SUBJECT: Sampling and Analysis Plan Addendum for the P-Area Groundwater Operable Unit (U) (SRNS-RP-2018-00261, Revision 1, August 2018) (Clean Copy and Redline Pages) and the Savannah River Site's Responses to the Regulatory Comments on the Revision 0 Document, CERCLIS Number: 81

SRS Responses to South Carolina Department of Health and Environmental Control
 Comments on the
 Sampling and Analysis Plan (SAP) Addendum for the P-Area Groundwater Operable Unit
 SRNS-RP-2018-00261, Revision 0, February 2018, CERCLIS Number: 81
 Savannah River Site NPL Site, South Carolina
 Page 6 of 6

Revised Figure 25. Proposed Surface Water and Well Locations in Steel Creek, PAGW OU

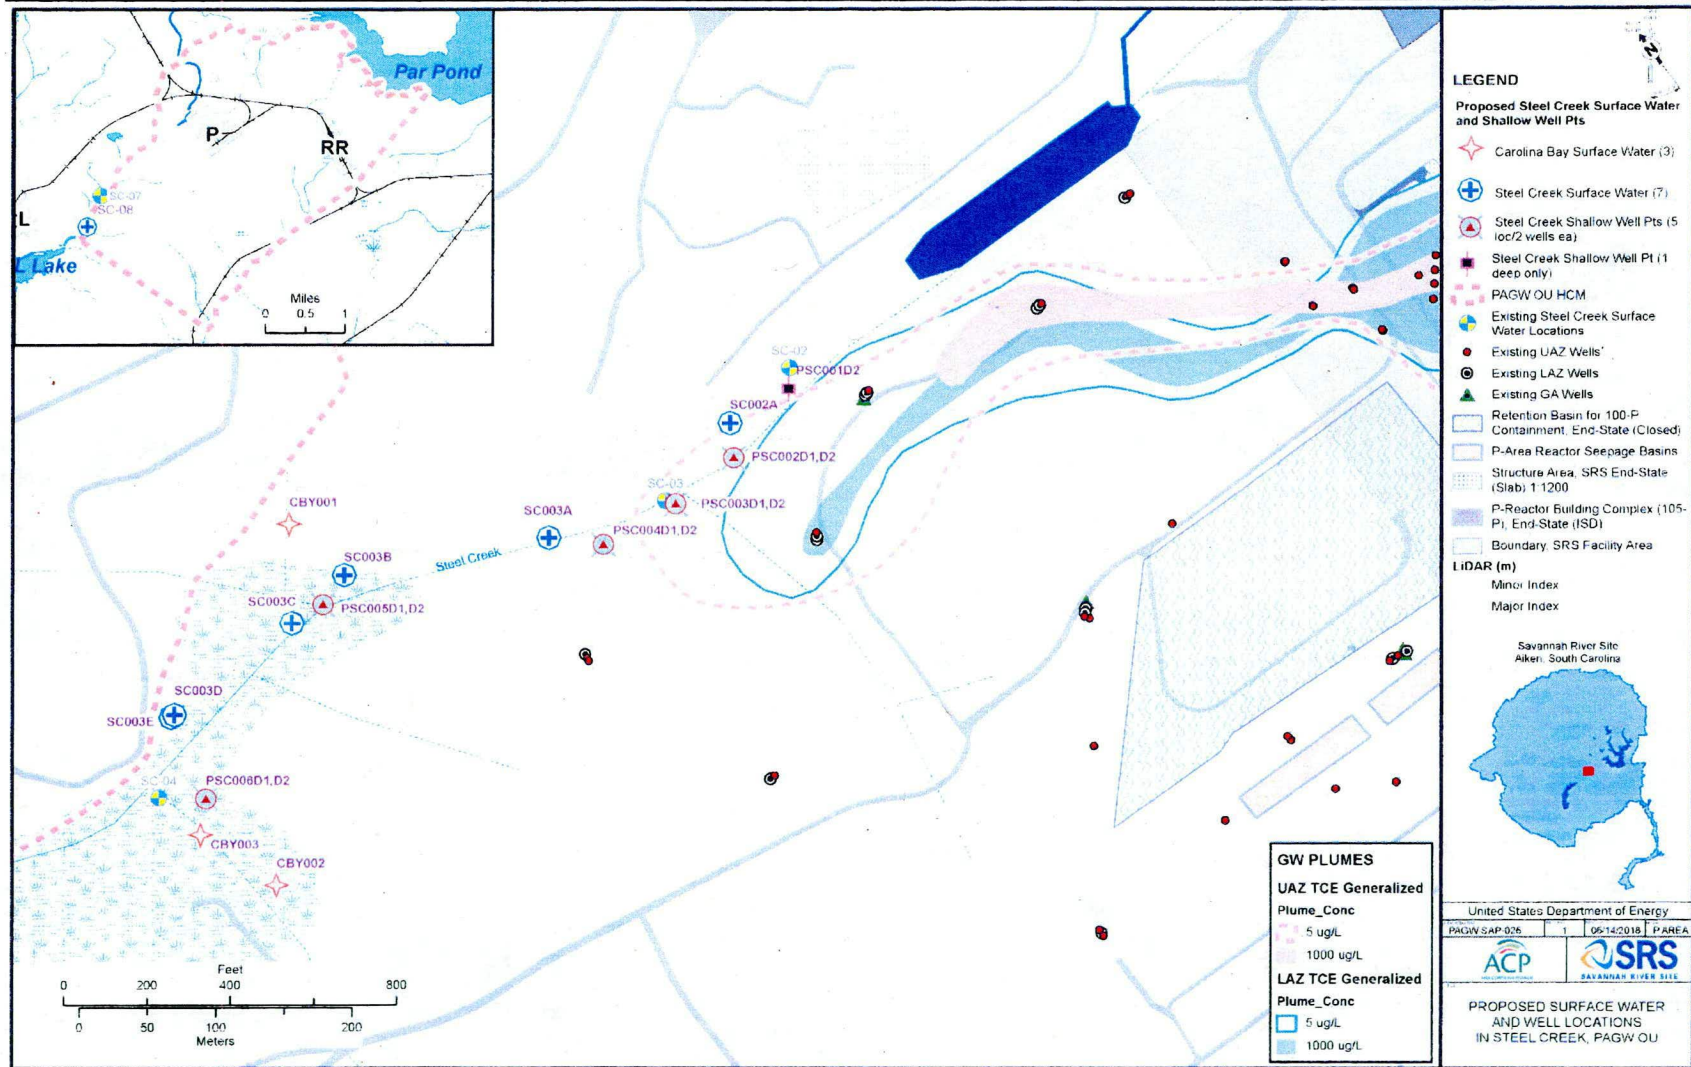
5. Section 4.1, Steel Creek Investigation, page 30, third paragraph. Four existing surface water locations (SC-02, -03, -04, and -07) will be sampled with the proposed new surface

water locations. Figure 3 on page 46 includes SC-05 and SC-06 and appear to be outside the PAGW OU HCM; however, Figure 25, page 68, indicates that proposed water locations SC003D and SC003E also fall outside the PAGW OU HCM. Please clarify why SC-05 and SC-06 are not sufficient for sampling in determining the extent of VOC contamination in the distal area and impact to Steel Creek.

Response: Clarification. The HCM [hydrogeologic conceptual model] boundary does include the entire floodplain of upper Steel Creek but was drawn at a large scale that did not include some of the specific locations. To make it clear that locations SC003D and SC003E are part of the PAGW OU, the HCM boundary will be redrawn to include these locations (see attached revised Figure 25).

Locations SC-05 and SC-06 are located significantly downgradient of where the groundwater plumes are discharging to Steel Creek and thus do not provide unique data from SC-07 and SC-08. The new locations SC003D and SC003E were proposed as part of the SAP to provide specific data regarding TCE concentrations up and down stream of a natural dam in the creek. No additional detail to the text is proposed.

Revised Figure 27. Proposed Steel Creek Surface Water Monitoring Locations, PAGW OU

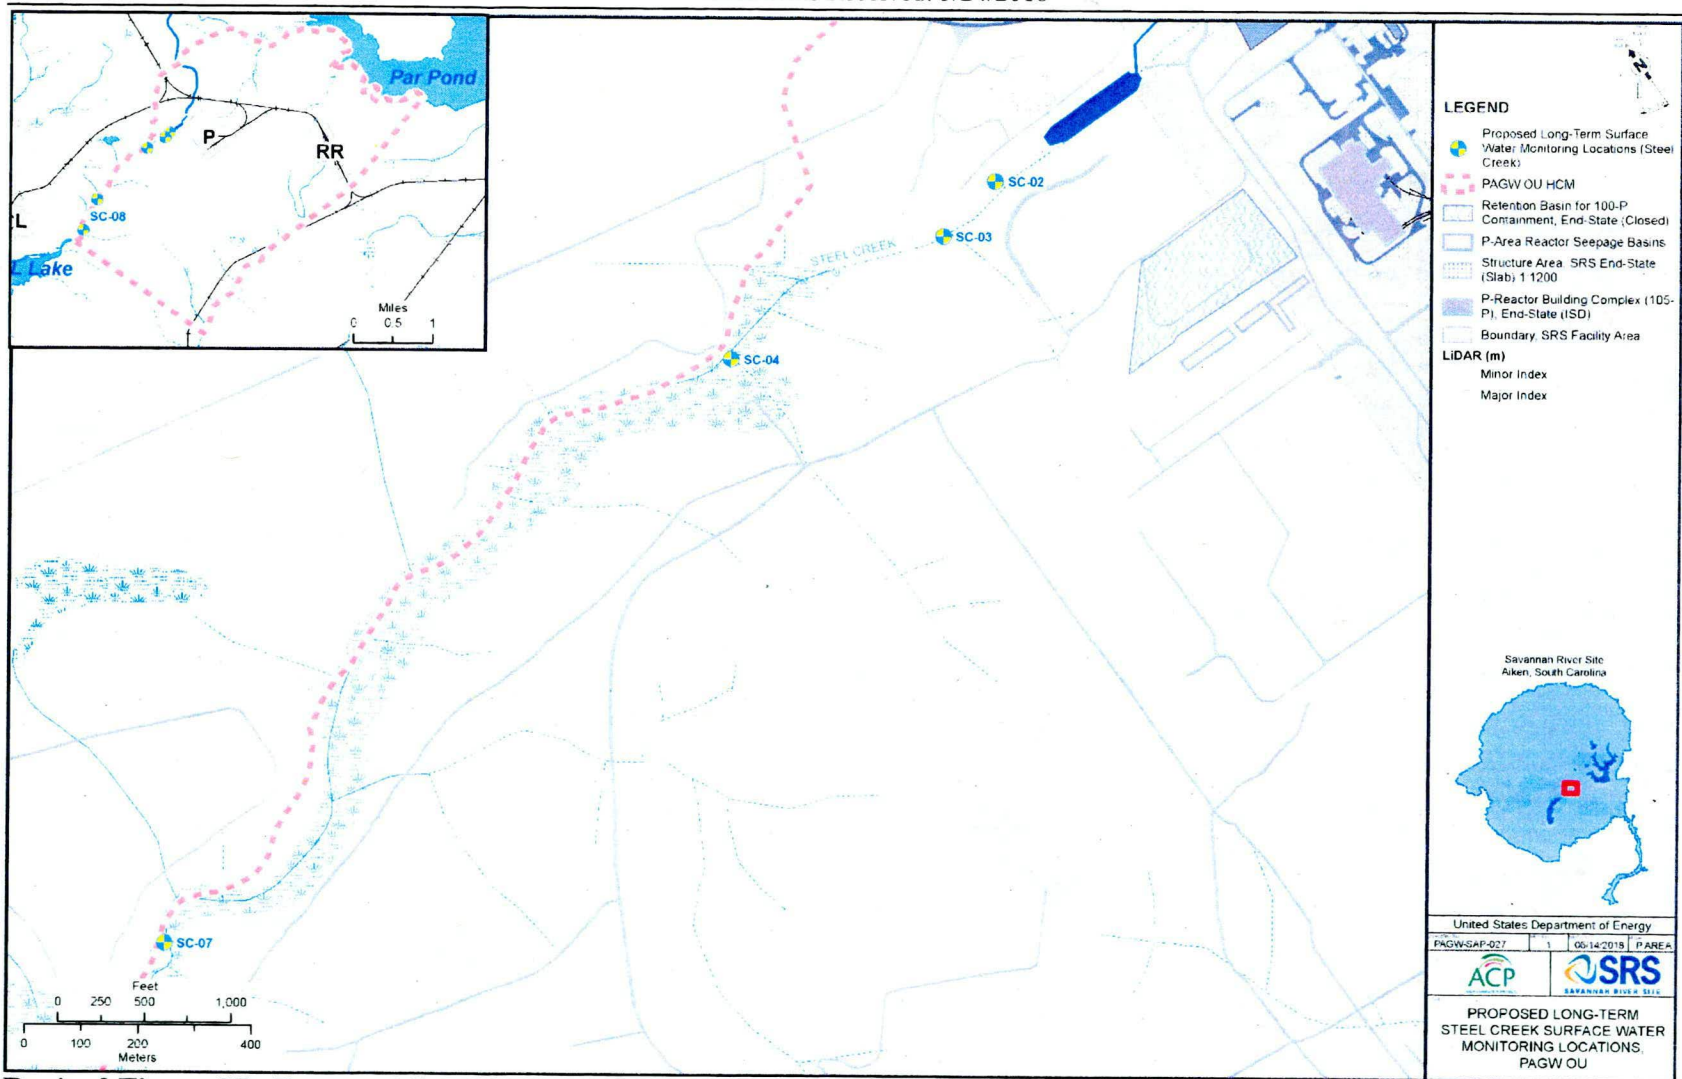
6. Figure 27, Proposed Steel Creek Surface Water Monitoring Locations, PAGW OU, page 70. Please include new location SC-08 on this figure, as indicated in the Surface Water discussion on page 23.

Response: Agree. Surface water location SC-08 will be added to Figure 27 (see attached revised Figure 27).
